Doc Ref: WD634-01F01(rev3)- NV Memo

**RE: MARRICKVILLE COMMUNITY HUB, 313-319 MARRICKVILLE ROAD,
MARRICKVILLE
NATURAL CROSS VENTILATION MEMO**

MARRICKVILLE COMMUNITY HUB - RESPONSE TO PLANNING COMMENTS APRIL 2017

Figure 1 – Floorplan Layout Incorporating Recommended Treatments

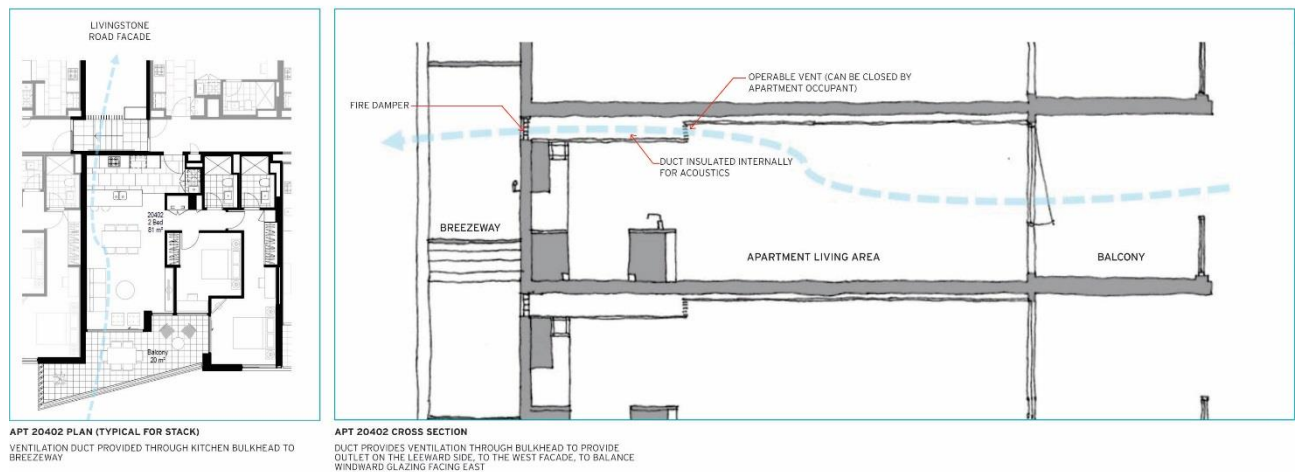
This technical memo is in relation to the proposed development known as Marrickville Community Hub, located 313-319 Marrickville Rd, Marrickville and the comments provided by Council in its letter of 7 March, 2017, regarding the natural cross-ventilation characteristics of the following apartments:

- Apartment 20407 (and those of the same type): The inclusion of an opening along the western façade of the main bedroom. This would introduce an opening on an orthogonal aspect and promote the pressure driven airflow through the apartment between the more positively pressurised north-facing opening at the living area; capturing the prevailing north-easterly winds, and exhausted to the recommended opening which is more negatively or neutrally pressurised.

- Apartment 30301: The inclusion of an opening along the north-western façade of the secondary bedroom. This would introduce an opening on an orthogonal aspect and in conjunction with the proposed full-height impermeable wall along the north-western perimeter edge of the balcony, it would be effective in creating differing pressure regions at the various openings; more positively pressurised at the north-facing openings and negatively or neutrally pressurised at the recommended opening, and promote the pressure driven airflow through the apartment.

- Apartment 10302: The inclusion of an opening along the southern façade of the main bedroom. This would introduce an opening on an orthogonal aspect and promote the pressure driven airflow through the apartment between the more positively pressurised east-facing opening at the living area; capturing the prevailing north-easterly winds, and exhausted to the recommended opening which is more negatively or neutrally pressurised.

- Apartment 10303: The inclusion of an opening along the eastern façade of the primary bedroom. This would introduce an opening on an orthogonal aspect and promote the pressure driven airflow through the apartment between the more positively pressurised south-facing opening at the living area; capturing the prevailing southerly winds, and exhausted to the recommended opening which is more negatively or neutrally pressurised.

- Apartment 20307: The design, location and orientation of the apartment is similar to Apartment 20407, hence the abovementioned recommendations for Apartment 20407 is applicable.

- Apartment 20308: The inclusion of an opening along the north-western façade of the secondary bedroom. This would introduce an opening on an orthogonal aspect and in conjunction with the proposed full-height impermeable wall along the north-western perimeter edge of the balcony, it would be effective in creating differing pressure regions at the various openings; more positively pressurised at the north-facing opening of the living area and negatively or neutrally pressurised at the recommended opening, and promote the pressure driven airflow through the apartment.

- Apartment 20001: The inclusion of an opening along the western façade of the secondary bedroom on the Upper Level 01. This would introduce an opening on an orthogonal aspect promote the pressure driven airflow through the apartment between the more positively pressurised north-facing opening at the living area on the ground

level; capturing the prevailing north-easterly winds, and exhausted to the recommended opening which is more negatively or neutrally pressurised.

- Apartment 20002: We are in agreement that the design of the apartment will not display effective natural cross-ventilation through the apartment.
- Apartment 20003: We are in agreement that the design of the apartment will not display effective natural cross-ventilation through the apartment.

Note recommended openings have a minimum effective openable area of 0.4m². Based on our extensive experience and research into natural cross ventilation characteristics of residential apartment buildings utilising wind tunnel testing as well as full-scale verification testing (Peddie and Rofail, 2011) this is the minimum effective openable area required to generate pressure driven airflow between openings. Furthermore this has been established as an acceptable minimum openable area as part of the Land and Environment Court Case (Case number 10266 of 2015) between the City of Sydney Council and the proposed development at 216-228A Elizabeth Street, Surry Hills.

Of the above mentioned apartments only 20002 and 20003 do not achieve natural cross ventilation. In place of these, we have worked with Mirvac Design and TZG to introduce a vent with a cross sectional area of 0.4m² to each stack of 6 apartments in the centre of Building A, Apartment 20302 and above to Level 8. This vent connects through to the break in the building from the west, allowing cross flow with glazing in the apartment facing east.
